March 10, 2005

RE: PROP, 131 – 133 Anderson St. Portland, ME  
CBL: 012 B0- 09

We've reviewed the list of comments on the submitted plans and listed below where the information is located, or what our proposed solution will be. Once reviewed and approved we will assemble an Addendum to incorporate the revisions as necessary. I've also attached your letter for easy reference.

**ANDERSON STREET - BUILDING 2**  
PEOPLE'S REGIONAL OPPORTUNITY PROGRAM  
Portland, Maine

SHEET TITLE:  
EXTERIOR RAMP  
FRAMING PLAN

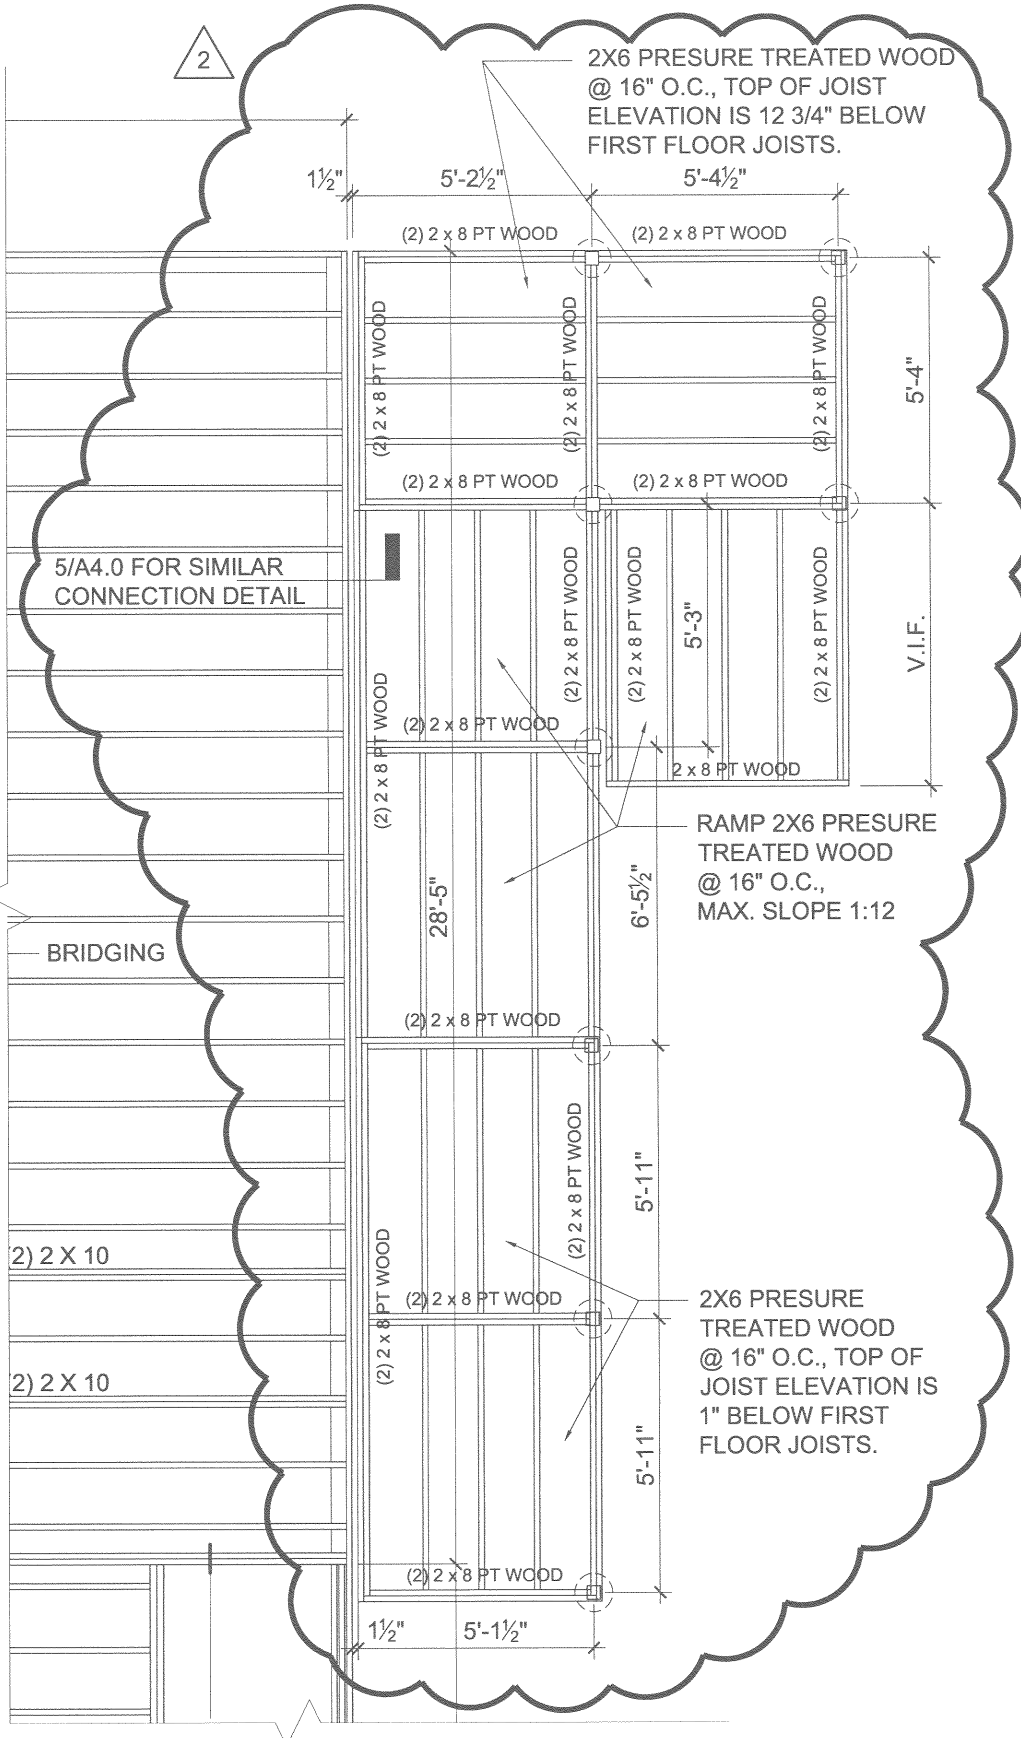
- b. The handicap access ramp is indicated in part in the 1<sup>st</sup> floor plan and detail 6/A4.0. Construction is similar to the porch section in details 5 & 7/A4.0. Please see the attached framing plan SkS-1 for further information.
